Addendum #01

Project Name: Proposed Renovation and Addition: Ellisville City Hall and Police Station

Project Number: 20016

Date: 2023-03-17

C1 CLERESTORY REFLECTED CEILING PLAN
1/4" = 1'-0"

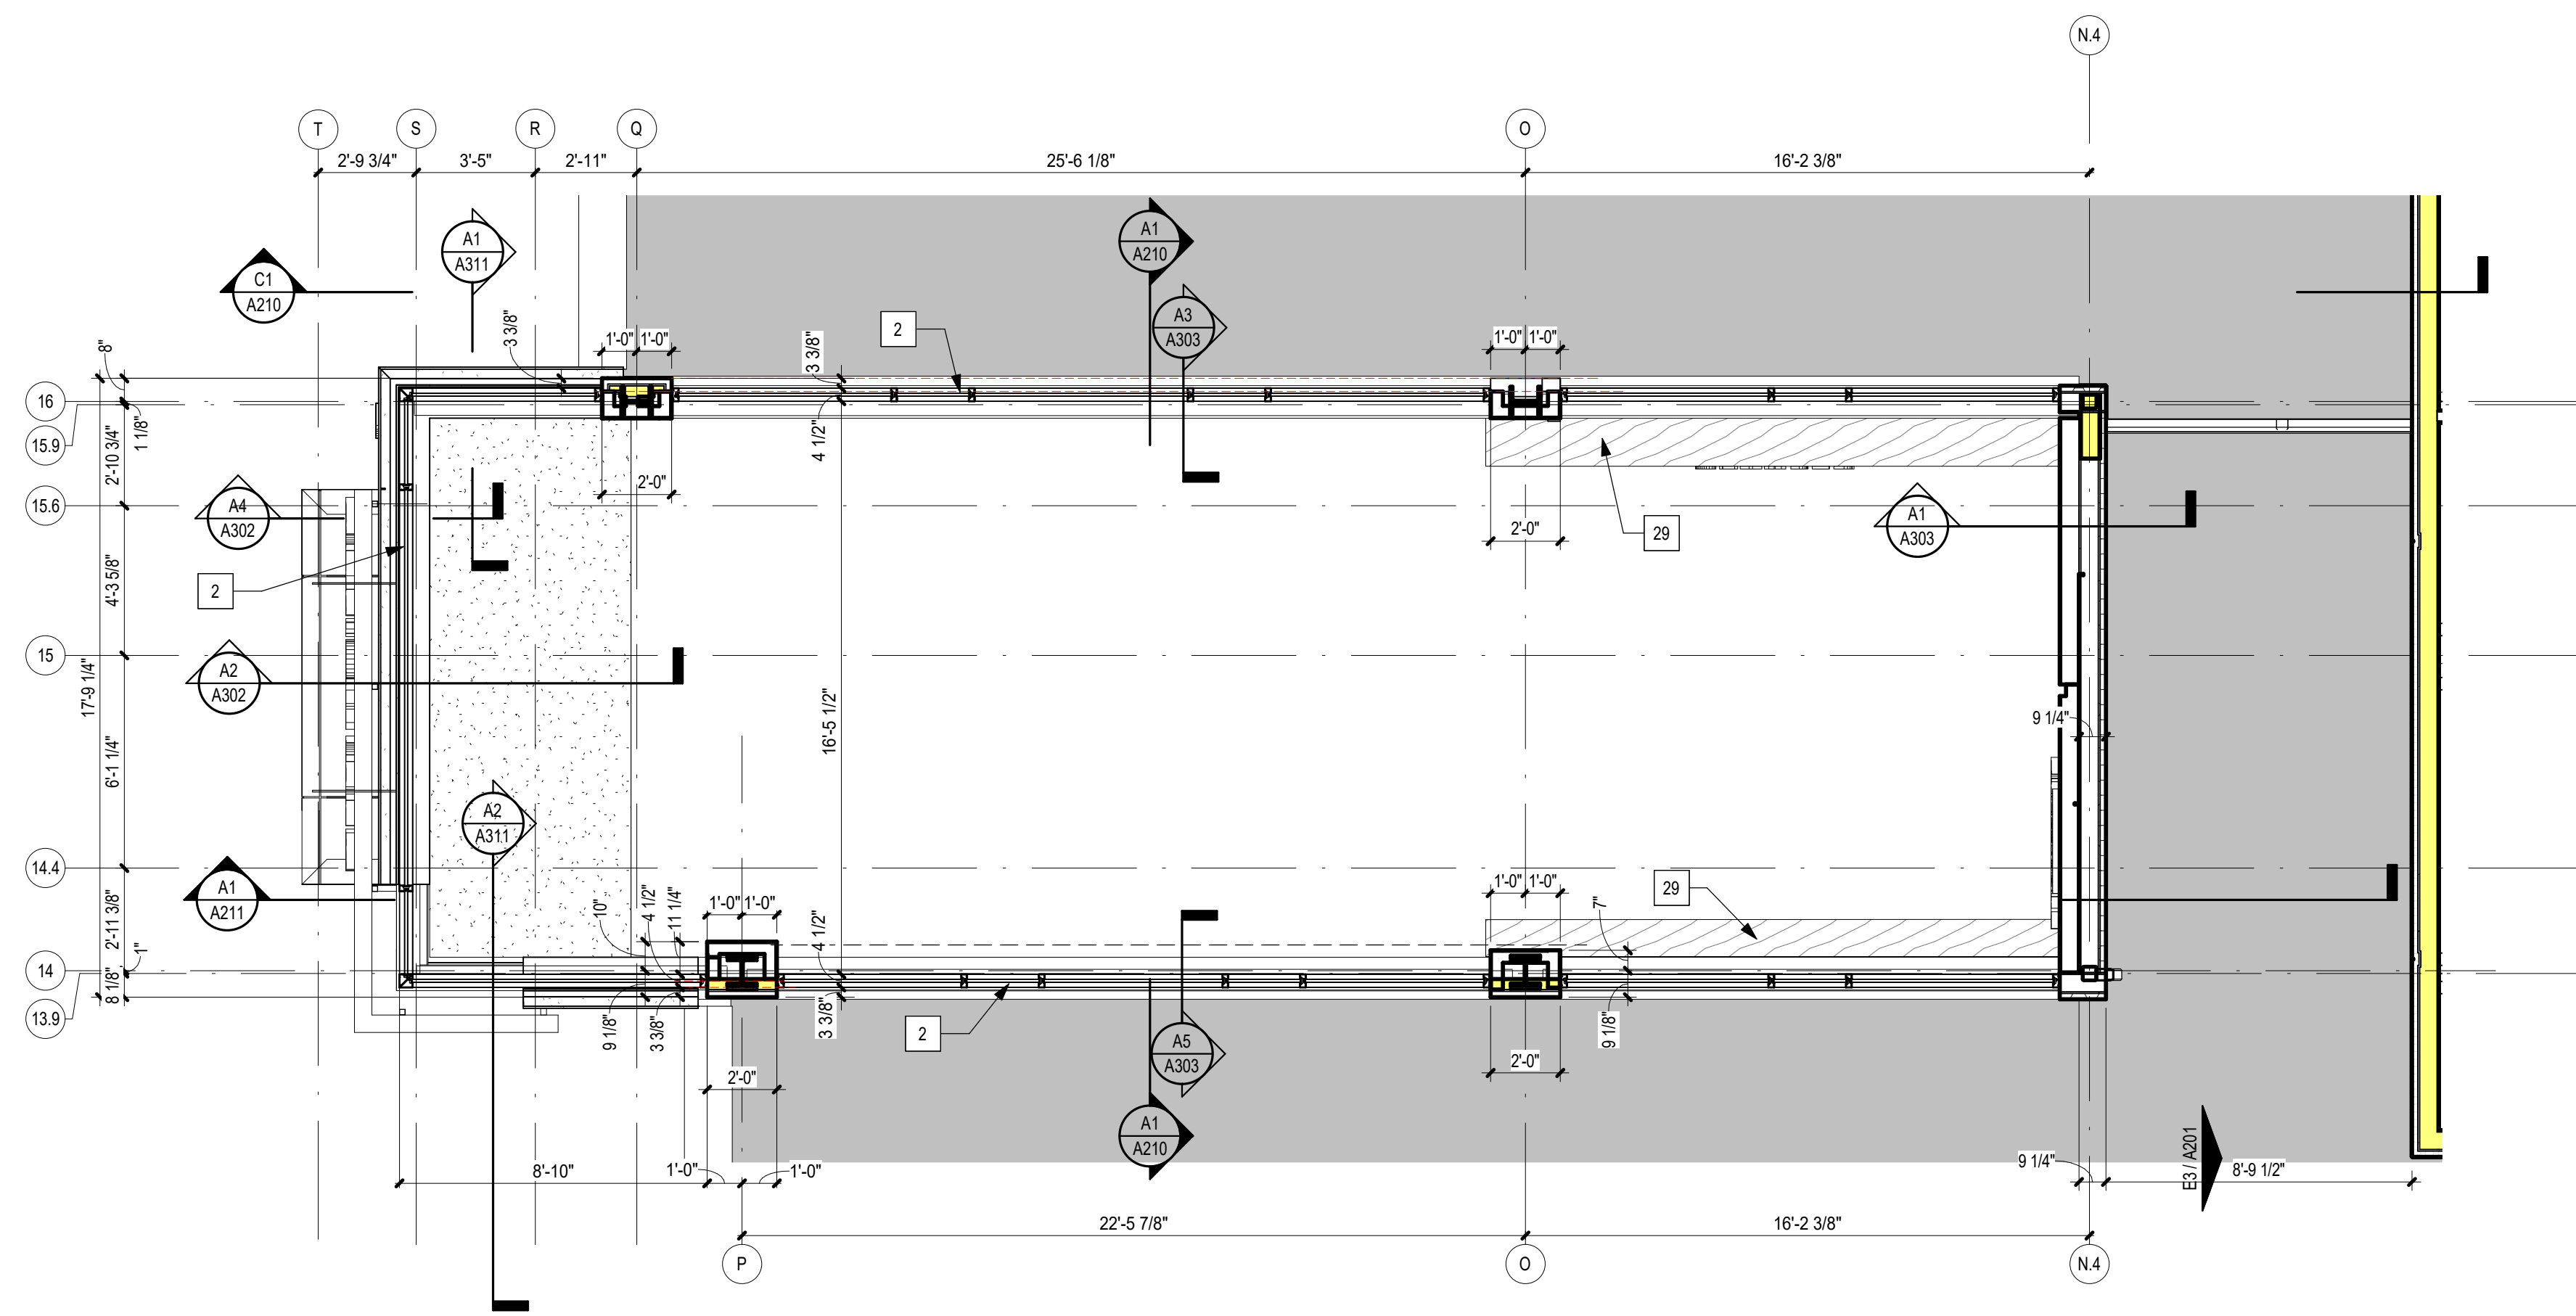
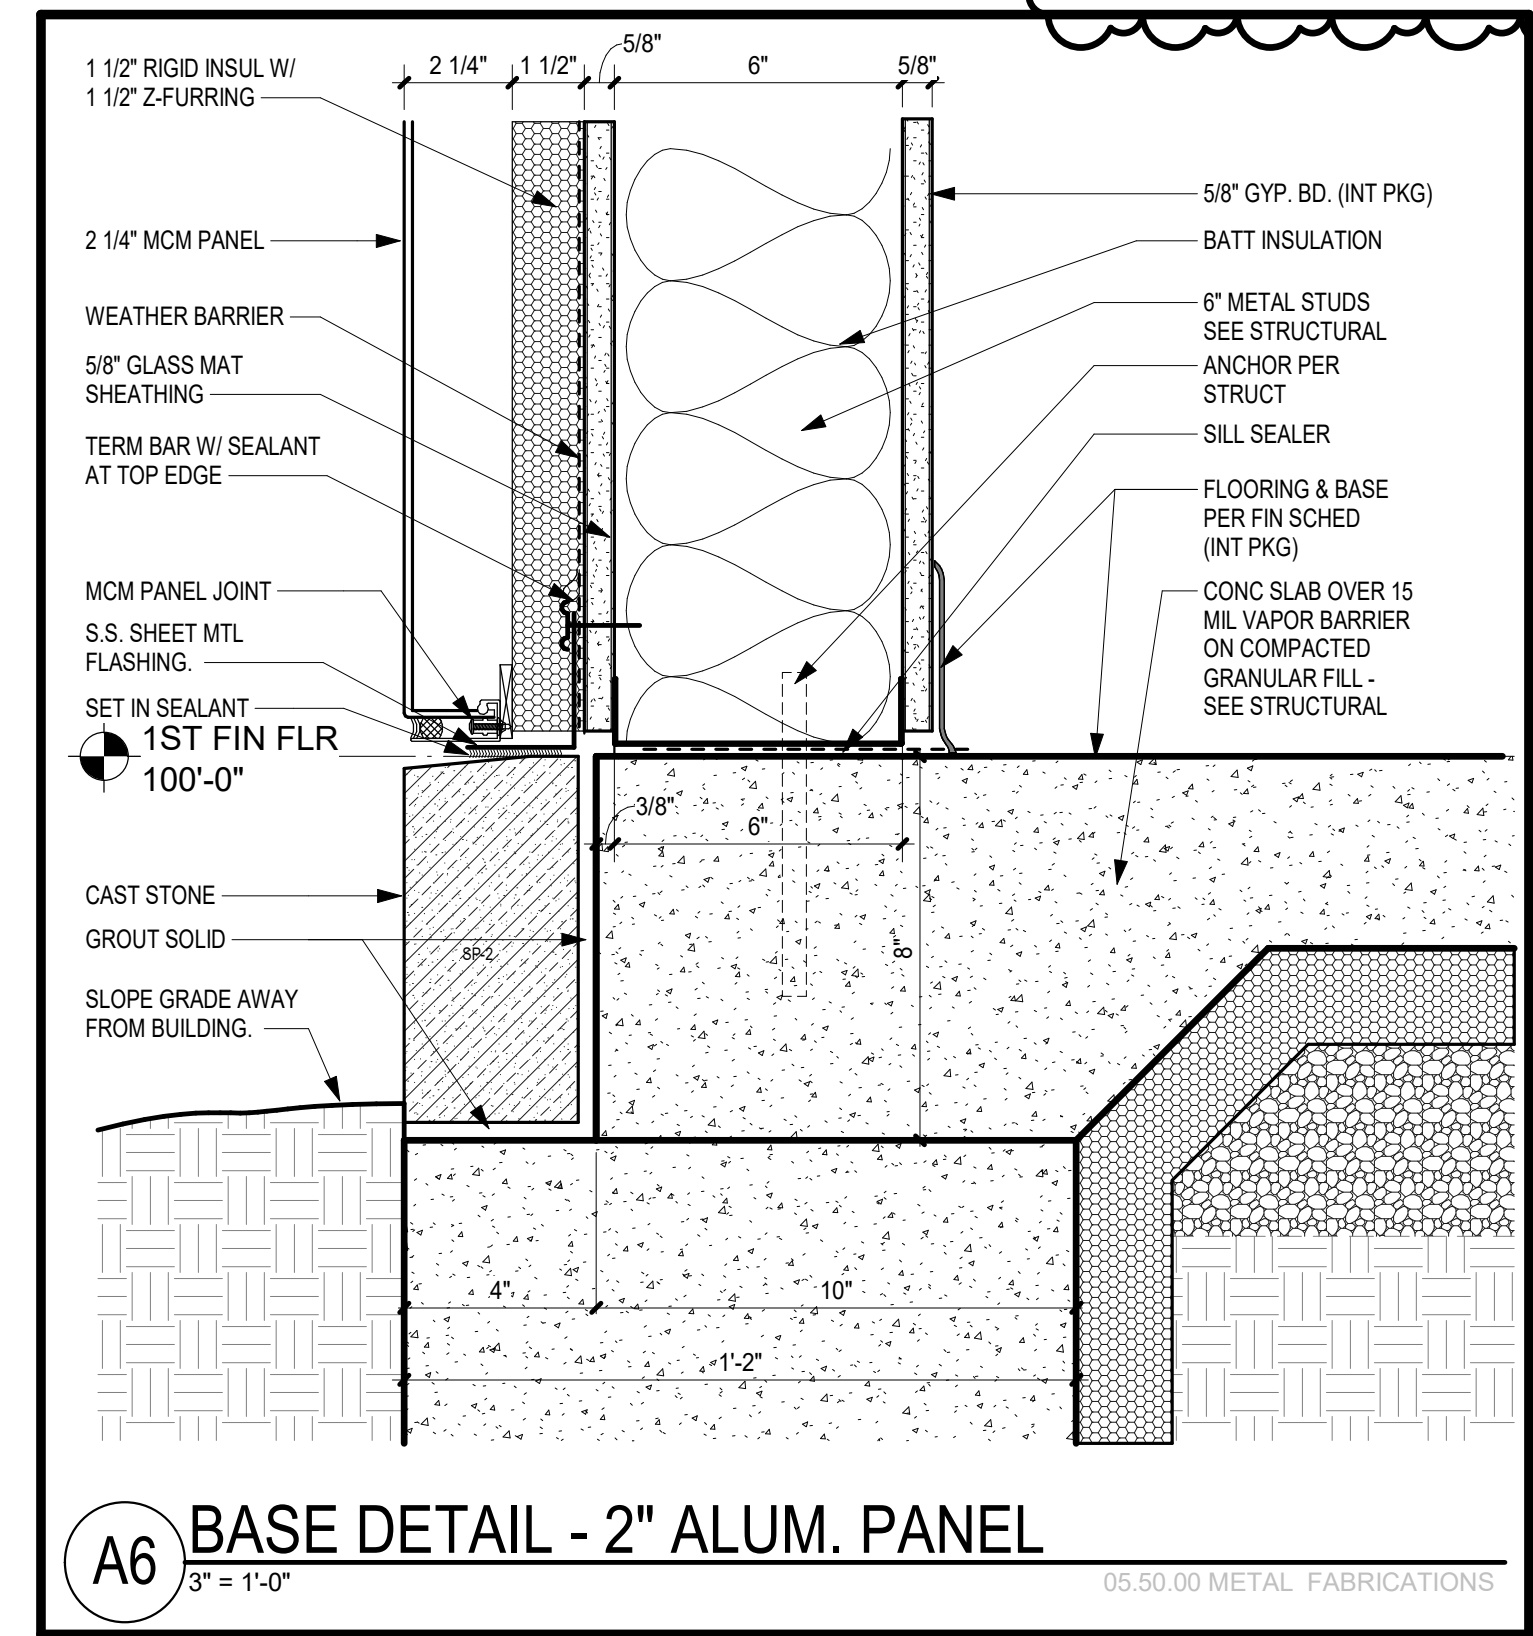
- a. **A1 Hid doors on Floor Plan and added Floor Plan Keynotes.**
 - b. **C1 Added dimensions and Keynotes to Reflected Ceiling Plan.**
 - c. **Added Keynote to Reflected Ceiling Plan and Floor Plan Legend.**

Project No. 20016
Sheet No. A216
Date 02/23/23

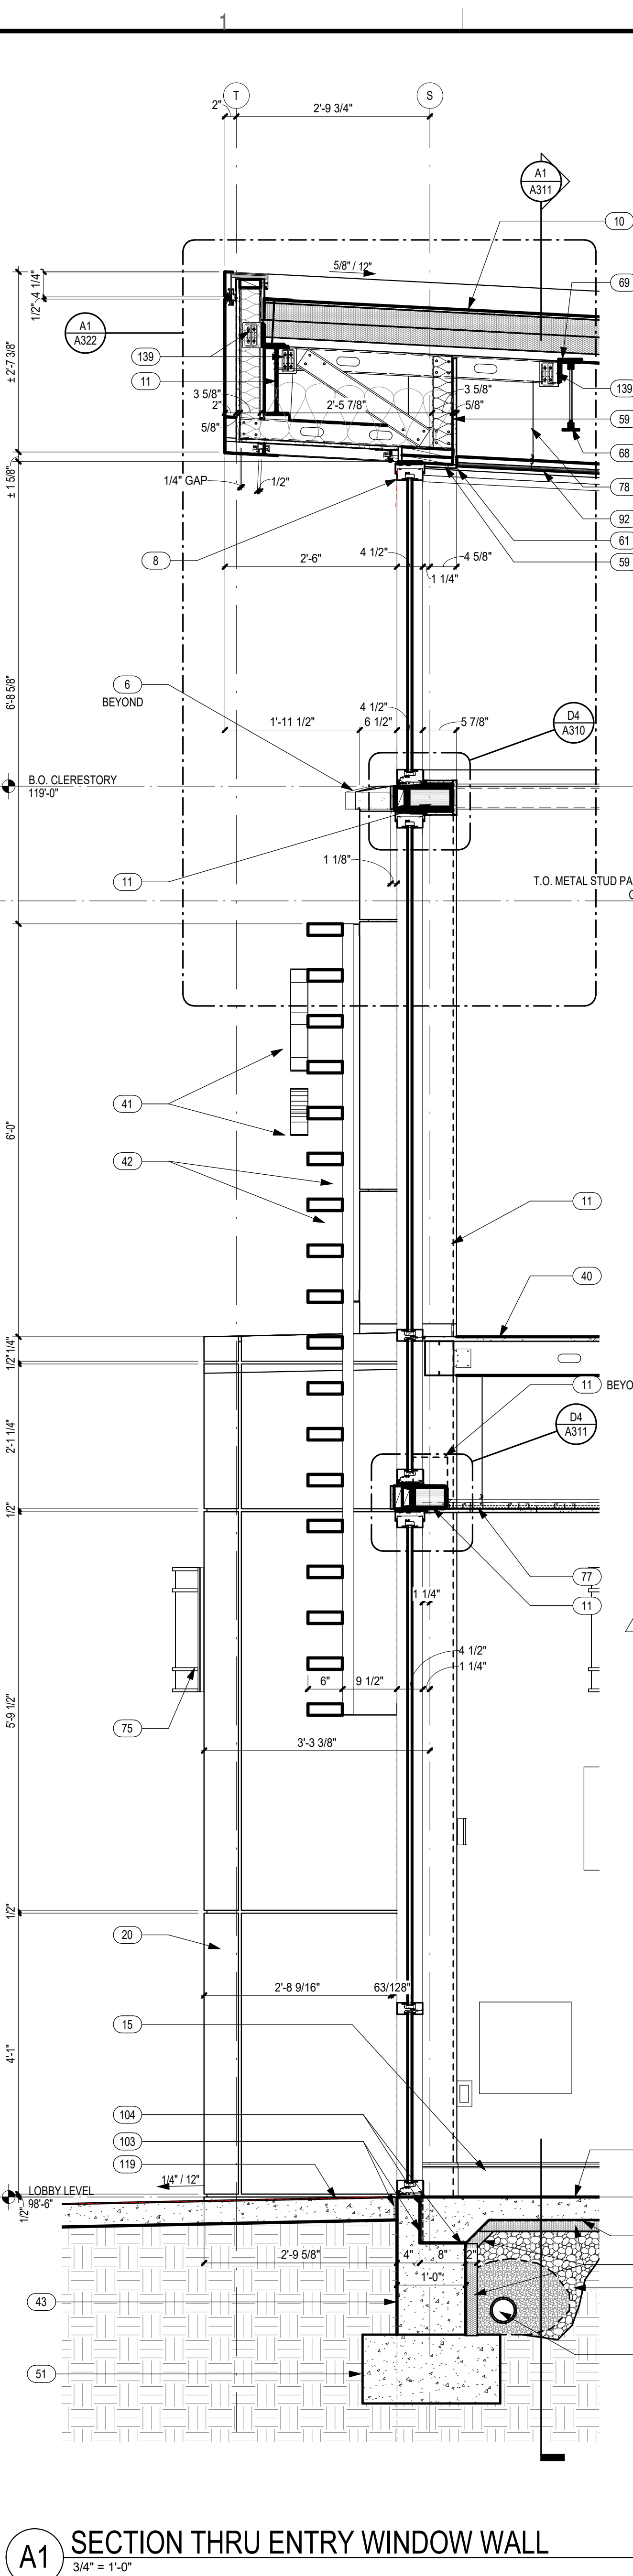
- b. **Reference attached Revised Sheet.**
4. Sheet A216: Elevator Sections and Details
 - a. **A1 and A3, added notes for clarity at existing Elevator and shaft.**
